UNITED STATES PATENT AND TRADEMARK OFFICE

Office Action Summary

10/538,487

POH ET AL.

FIGURE A

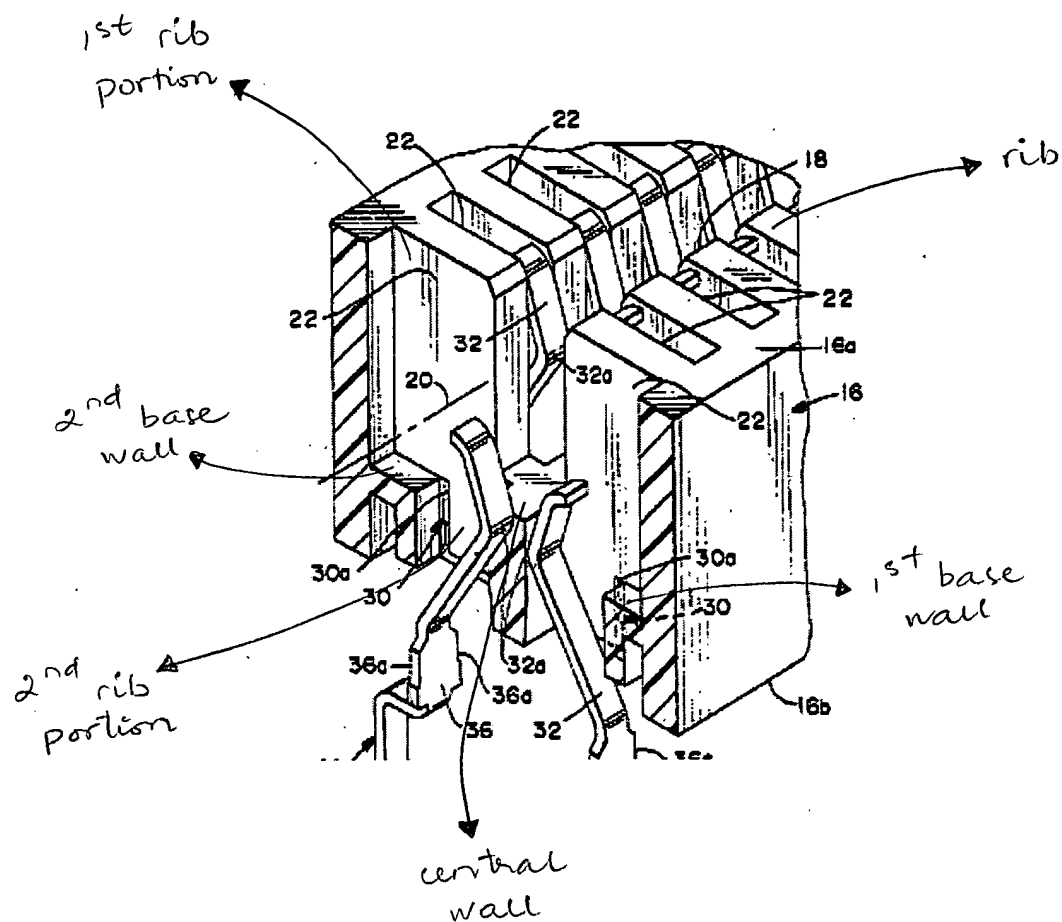
Regarding claims 1 and 17-18, DiViesti et al., figure 5 shows a connector comprising:

- a housing (16) including a first and a second base wall (a FIGURE A below), a plurality of ribs (the FIGURE A below) extending from the housing and spaced apart from each other such that a slot (22) is defined between adjacent ribs, each the ribs including a first rib portion and a second rib portion (the FIGURE A below) extending from a first direction and a second opposite direction, and a first slot portion, a second slot portion, respectively, from each the housing base walls; and
- at least one terminal (28) positioned within each the slots and connected to the housing such that a surface area (32a) of said at least terminal is exposed to the environment and air can flow over the surface area to dissipate heat from the at least one terminal.

Regarding claim 10, the housing including a central wall (the FIGURE A below) and the first and second housing base walls are connected to the housing central wall to define a first and a second aperture (not labeled).

Regarding claims 4, 12, DiViesti discloses the housing including a central wall (the FIGURE A below) and the first and second housing base walls are connected to the housing central wall to define a first and a second aperture (not labeled).
